Addendum #2

Project: MILWAUKEE PUBLIC LIBRARY GOOD HOPE MILL ROAD

Proj. #: 170044.00

From: Zimmerman Architectural Studios, Inc.

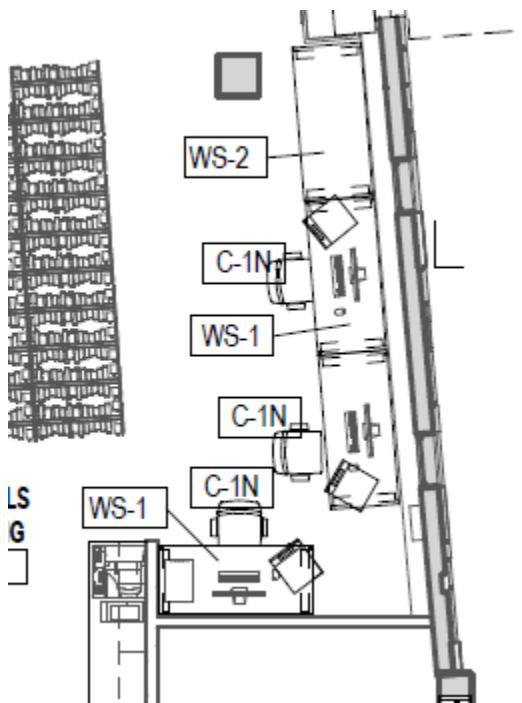
2. In the component notes, it says modesty panels shall be partial height. Does that include the main desk or do you want that to be a recessed full modesty panel?

ZAS RESPONSE: Partial height modesty panel on all WR-1, WR-2, WR-3
